**BAYOU BIENVENUE
CONTROL STRUCTURE**

PERIODIC INSPECTION REPORT NO. 4

SUBJECT: Lake Pontchartrain, Louisiana and Vicinity, Chalmette Area
Plan; Bayou Bienvenue Control Structure, Periodic Inspection
Inspection No. 4, March 1985

1. The enclosed periodic inspection report is approved subject to the following comments:

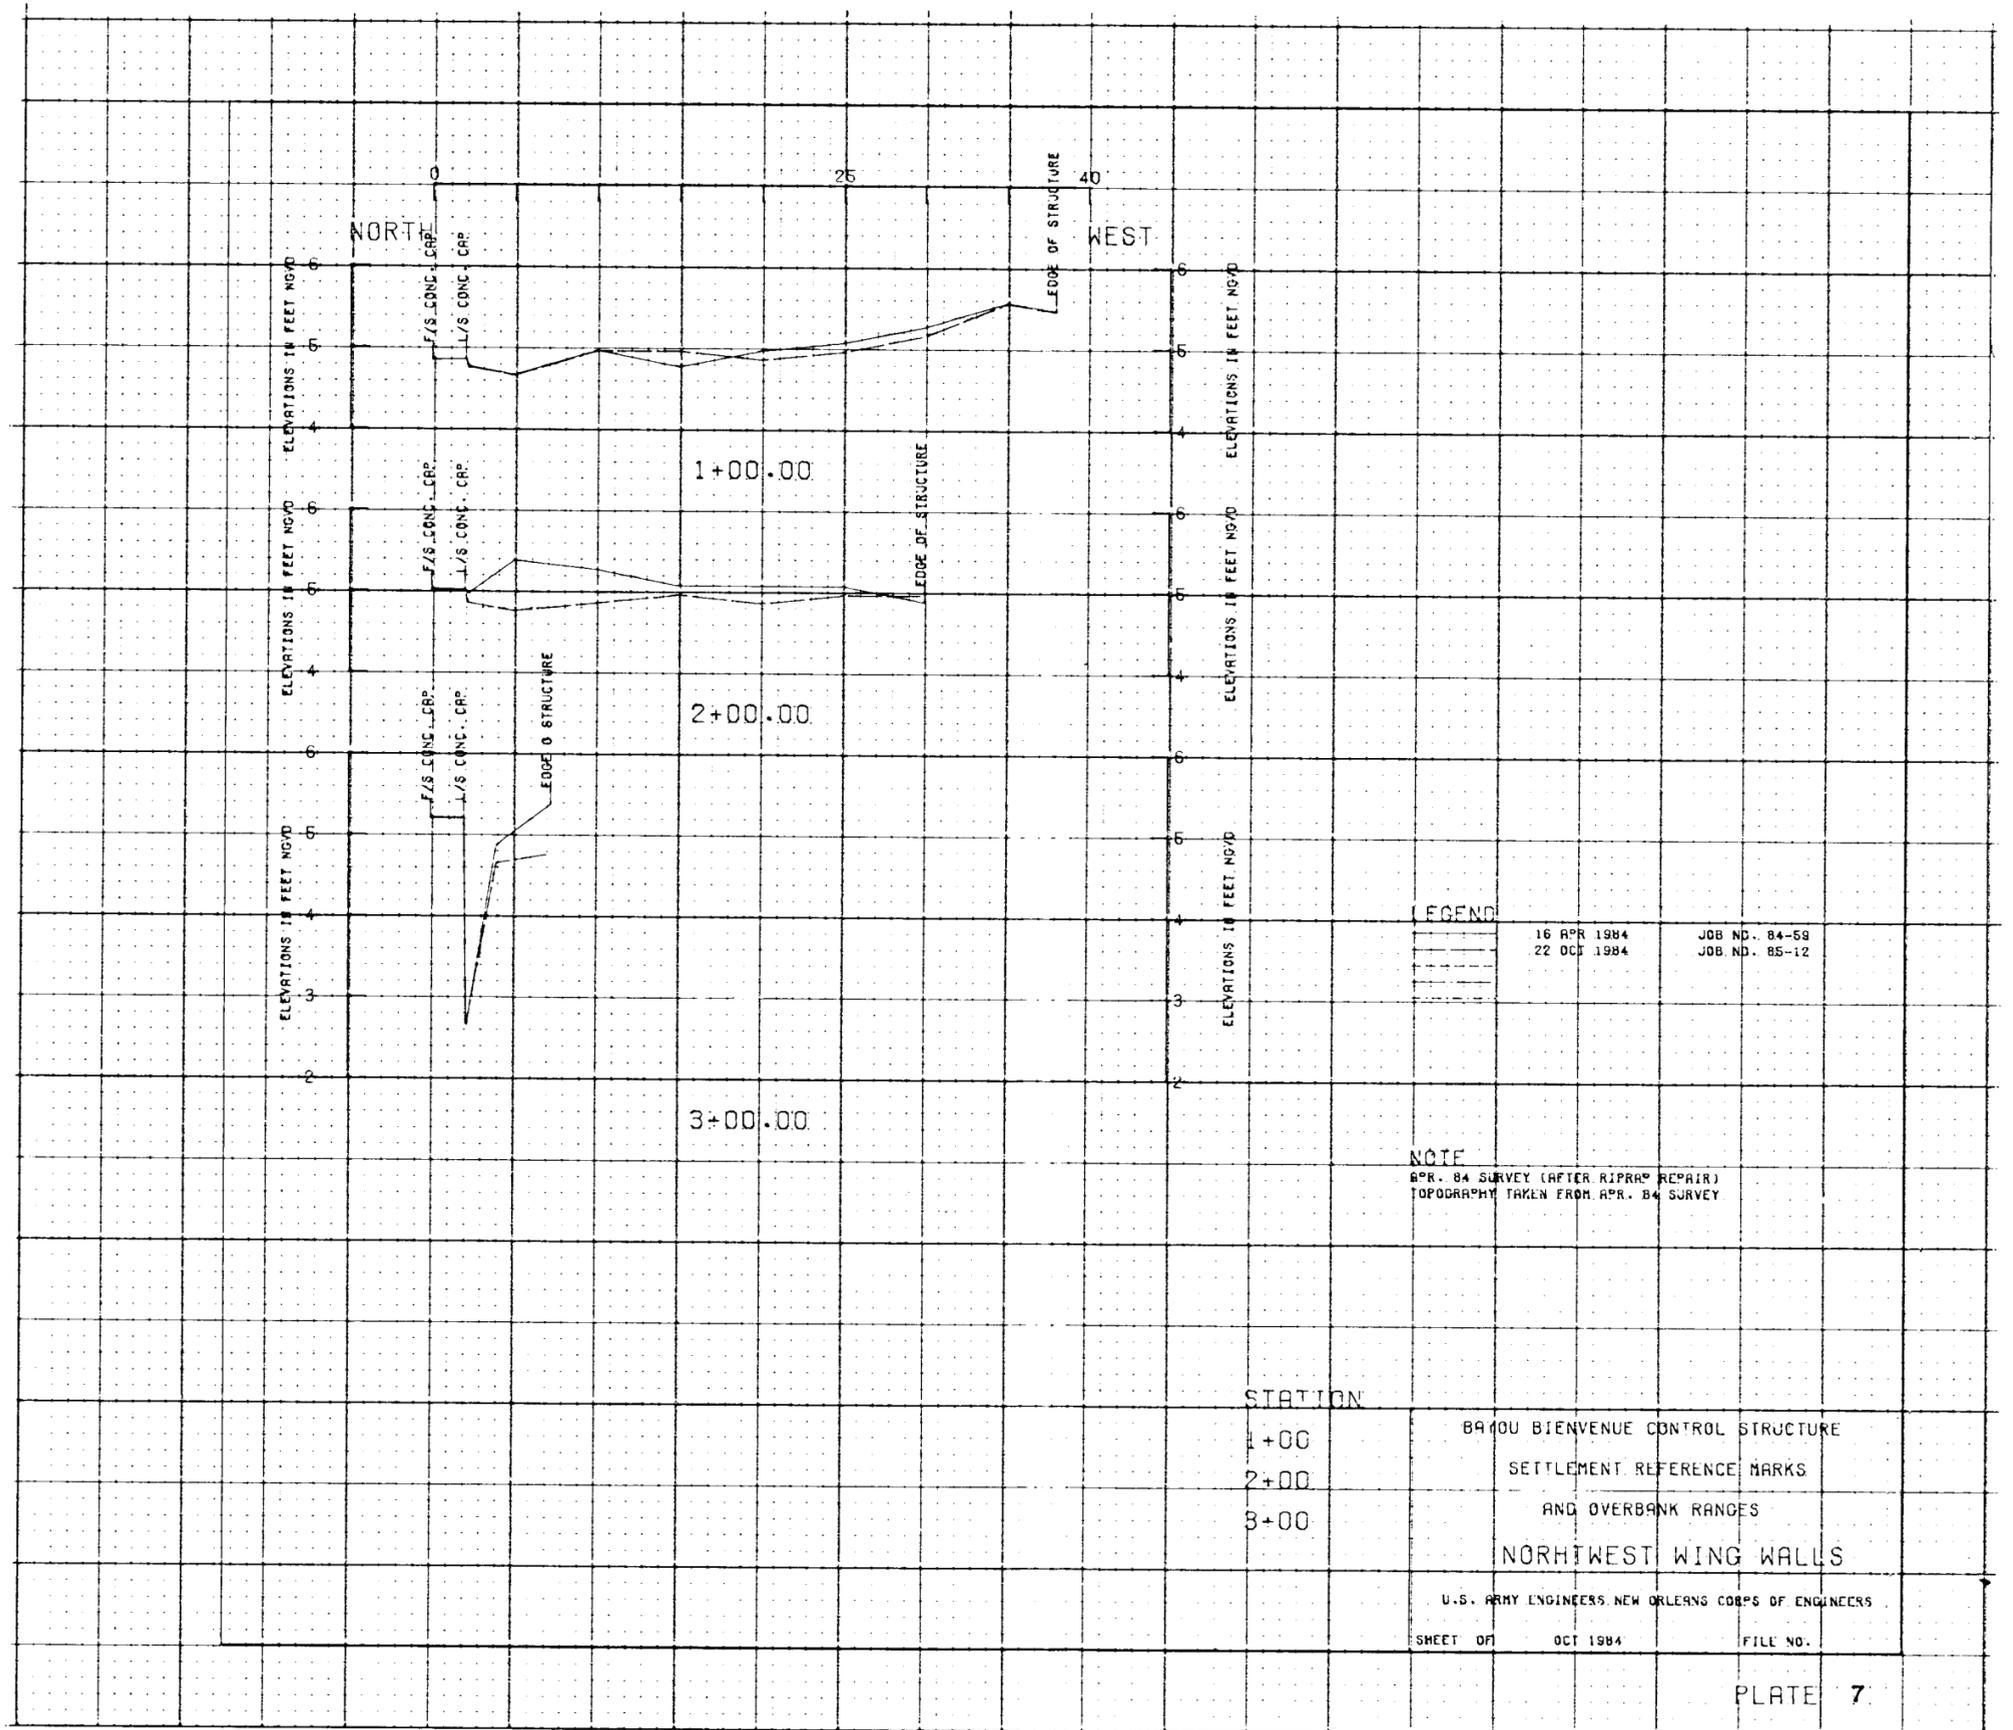
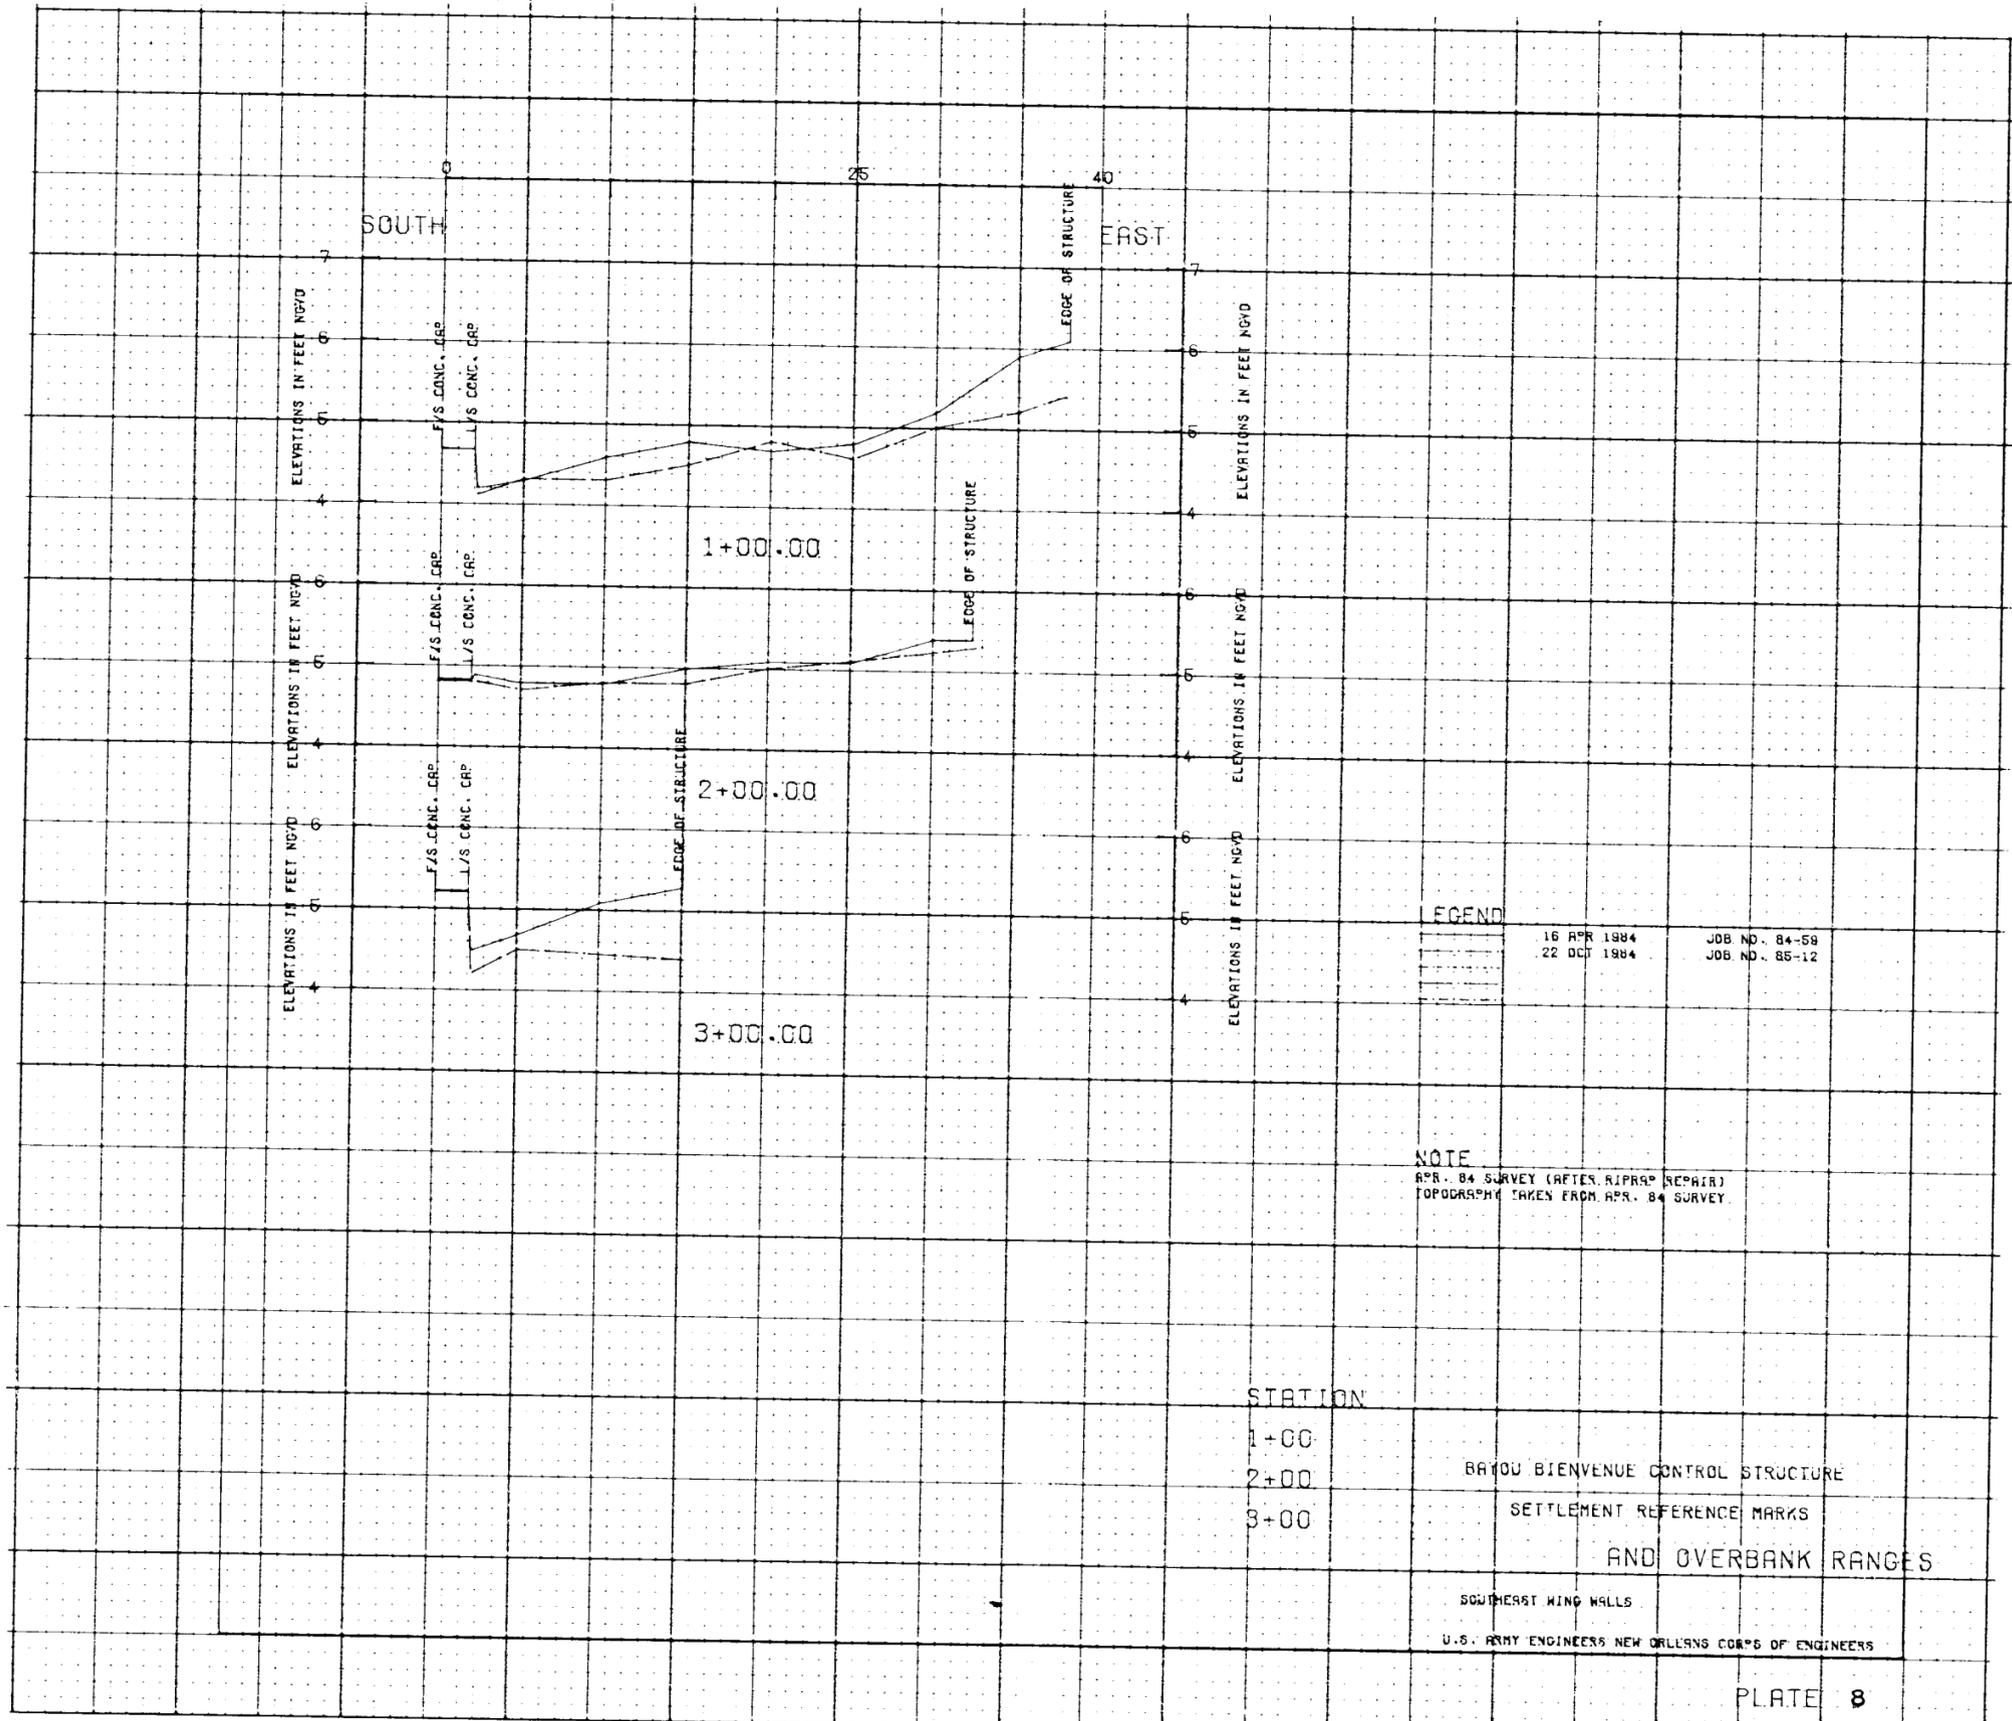
(c) Overbank Range Survey. The overbank range surveys, dated 22 Oct 84, indicate sinkholes or loss of material behind the northeast and northwest wingwalls at range 3+00. The surveys for the south wingwalls indicate very little settlement or loss of material behind the

walls. These sinkholes will be investigated during the upcoming inspection. Plates 6 through 9.

3. Erosion and Sinkholes. Sinkholes approximately 3 feet in diameter by 3 feet deep were observed at station 3+00 behind the northwest and northeast wingwalls. It seems the holes were caused by material being washed out past the rubber waterstop between the rubber waterstop between the structure and wingwalls. Also observed during the inspection was erosion on the ends of all the wingwalls.

e. Sinkholes and voids behind the wingwalls will be backfilled.
